09 May 2000

In response to your letter of April 12th, 2000 concerning the DRAXIMAGE LS-1 Brachytherapy implant we are pleased to provide the attached responses.

**RESPONSES TO
NUCLEAR REGULATORY COMMISSION
QUESTIONS CONCERNING
DRAXIMAGE LS-1
BRACHYTHERAPY IMPLANT**

Warning insert

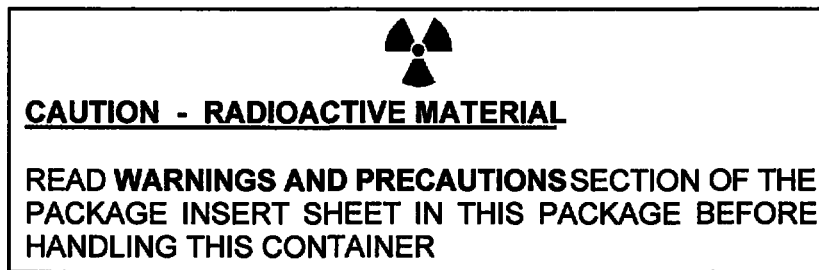
The NRC does not review the draft documents in the application. Please provide the complete and final documents for those which are marked as draft in the application (e.g., indications for use on Page 3 of Section 2, shipping pot label, primary container label, warning insert in Section 4, promotional material in Appendix 2).

In Section 4, please revise the trefoil symbol in accordance with 10 CFR 20.1901 on the shipping pot label, primary container label, and warning insert.

In Section 4, please add the following statement to the label in accordance with 10 CFR 32.74(a)(3): "The U.S. Nuclear Regulatory Commission has approved distribution of the LS-1 to the persons licensed to use byproduct material identified in 35.57, 35.400, or 35.500 of 10 CFR, as appropriate, and to persons who hold an equivalent license issued by an Agreement State."

In Section 4, per 10 CFR 32.74(a)(2)(viii), please provide the radiation safety instructions for handling and storing the source. These instructions are to be included on a durable label attached to a permanent storage container for the source. If these instructions are lengthy for such label, they may be summarized on the label and printed in detail on a brochure which is referenced on the label.

A revised package insert is attached.

DRAXIMAGE Type A Package

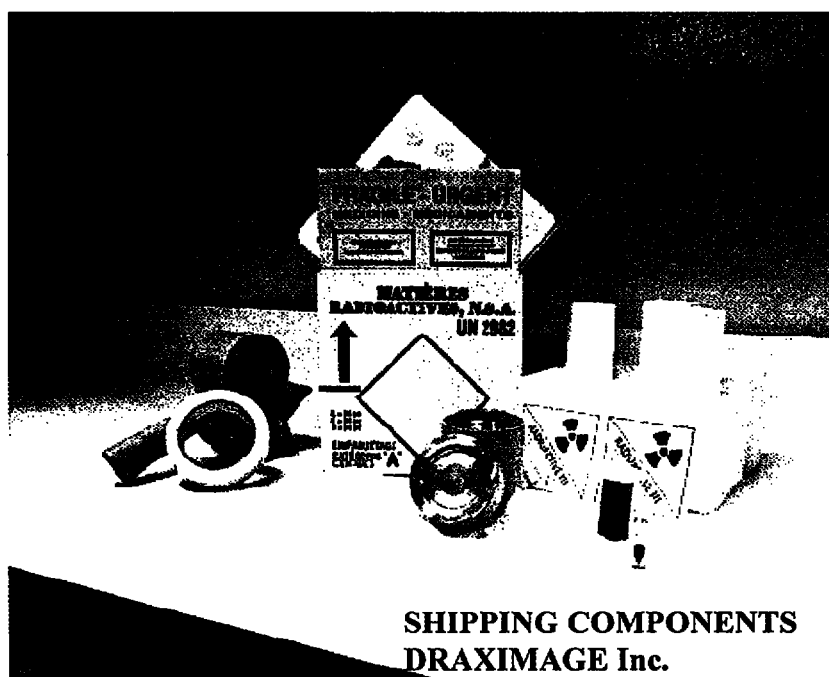
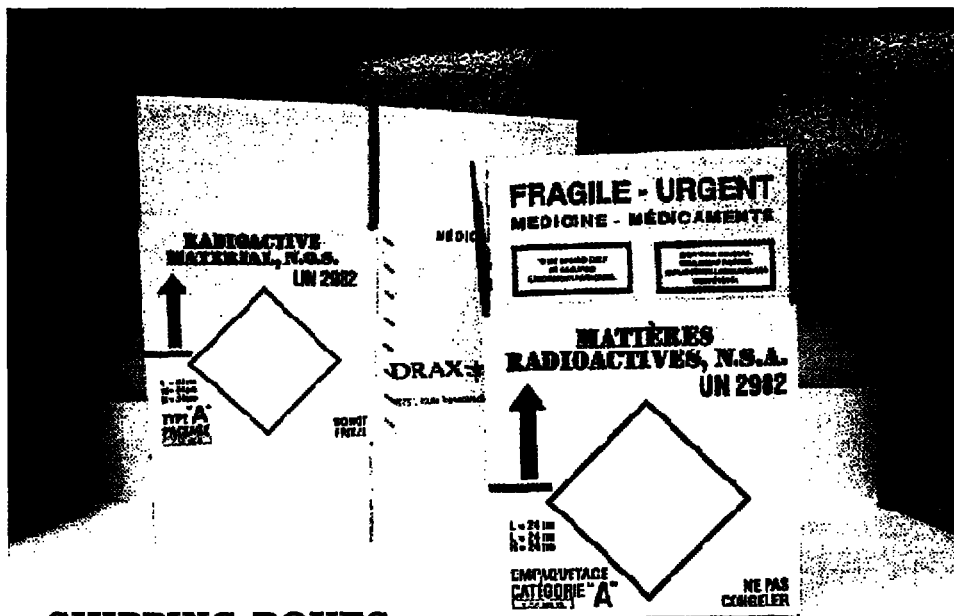
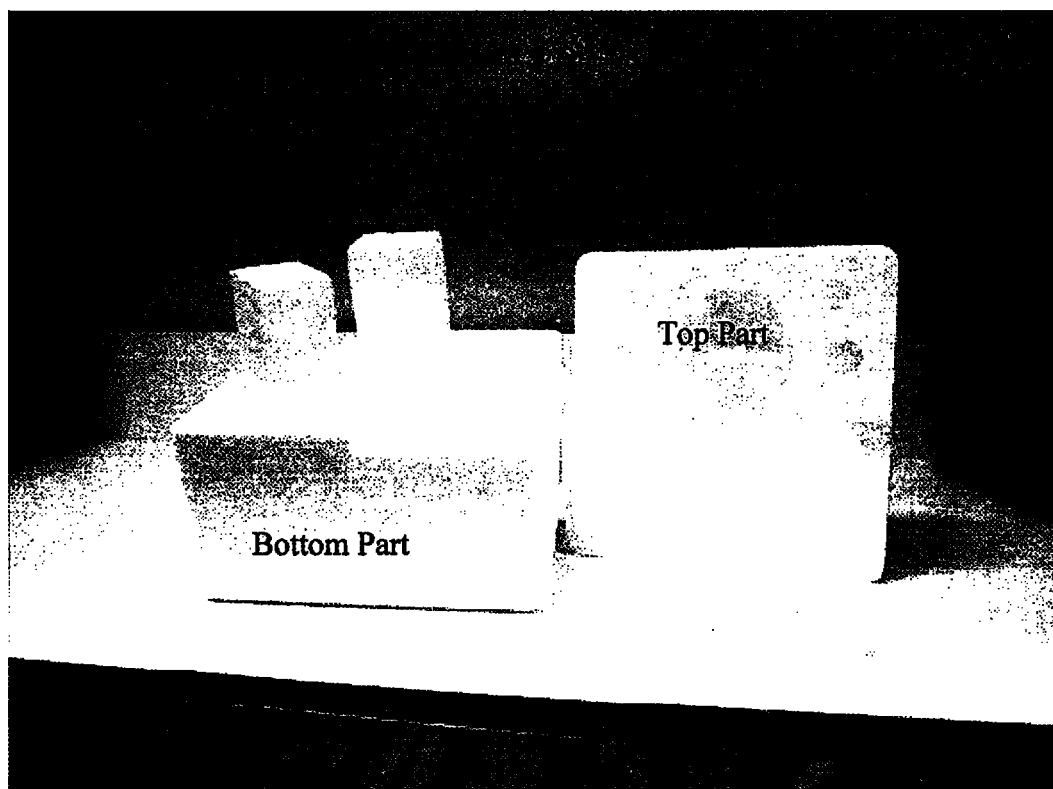
In Section 5, please provide integrity test results for the transportation/storage package. Your application has addressed the prototype testing of the individual beads. However, the integrity of the package, containing the beads, must also be addressed. Please provide information on package integrity. When addressing likely accident conditions for the package, please address such scenarios as dropping the package from the table top height to a concrete floor, or somebody placing a heavy object on the package.

The DRAXIMAGE Type A package system is a specially designed and tested shipping container for the transport of radioactive materials. Type A packages are capable of withstanding normal and accidental conditions of "ground" and "air" transport

The DRAXIMAGE packaging system meets all the tests required for shipping radioactive materials that are specified by the International Atomic Energy Agency (IAEA), the International Air Transport Association (IATA) and the Canadian Nuclear Safety Commission (CNSC).

The physical tests described in above regulations are intended to simulate conditions such as falling from vehicles, being dropped, being struck by a sharp object, being exposed to heavy rain, or having heavy cargo stacked on the package.

The Type A packaging system has been officially tested and a copy of the test report is attached in Appendix 1.
